Access Compliance Report

Public Rights-of-Way

(Curb Ramps)

Intersection ID: 8592	Main Street: PERIWINKLE_HILL_AV	Cross Street: IKEA_BV	Location: W
ADA ID: 58DCD93810FF	Ramp Type: Perp	Initial Pass/Fail: Fail	Overall Compliance: No
Severity Score: 13.75			
Codes/Mitigation Info/Possible Solution		Field Measurements/Component Compliance

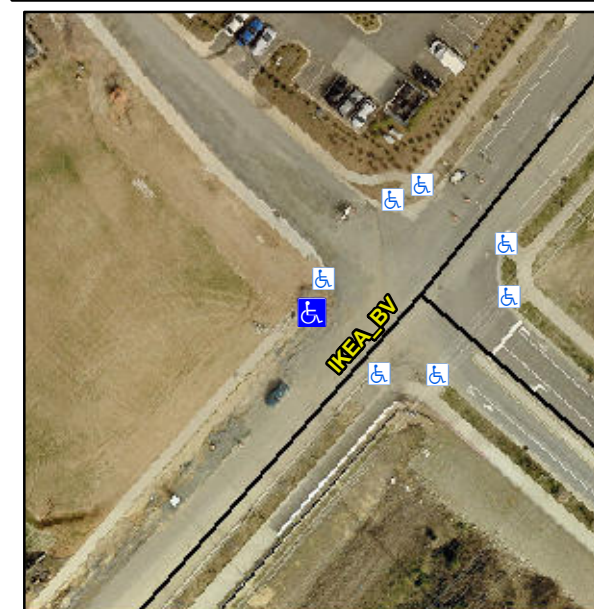
Not Found, R304.2.2, R304.5.3

Compliance	Description	Data	Compliance	Description	Data
N/A	Ramp Length (in)	78.0	No	Ramp Slope (%)	8.9
Yes	Ramp Width (in)	93.0	No	Ramp XSlope (%)	2.8
N/A	Flare Type LT	N/A	N/A	Flare Type RT	N/A
N/A	Flare Slope LT (%)	N/A	N/A	Flare Slope RT (%)	N/A
N/A	Flare Traversable LT?	N/A	N/A	Flare Traversable RT?	N/A
N/A	Landing Length (in)	N/A	N/A	DWS Provided?	N/A
N/A	Landing Width (in)	N/A	N/A	DWS Contrast?	N/A
N/A	Landing Slope (%)	N/A	N/A	DWS Length (in)	N/A
N/A	Landing X Slope (%)	N/A	N/A	DWS Full Width?	N/A
N/A	Landing Curb? (Y/N)	N/A	N/A	DWS Offset (in)	N/A
N/A	Shared Landing?	N/A			
N/A	Gutter Ponding?	N/A	N/A	Gutter Slope (%)	N/A
N/A	Gutter Lip Ht (in)	1.0	N/A	Gutter X Slope (%)	N/A
N/A	Painted X Walk1?	No	N/A	Painted X Walk2?	N/A
	X Walk 1 Direction	To SE		X Walk 2 Direction	N/A
N/A	X Walk 1 Width (in)	N/A	N/A	X Walk 2 Width (in)	N/A
	X Walk 1 Slope (%)	5.6		X Walk 2 Slope (%)	N/A
	X Walk 1 X Slope (%)	4.5		X Walk 2 X Slope (%)	N/A

Remove & Replace Entire Ramp.
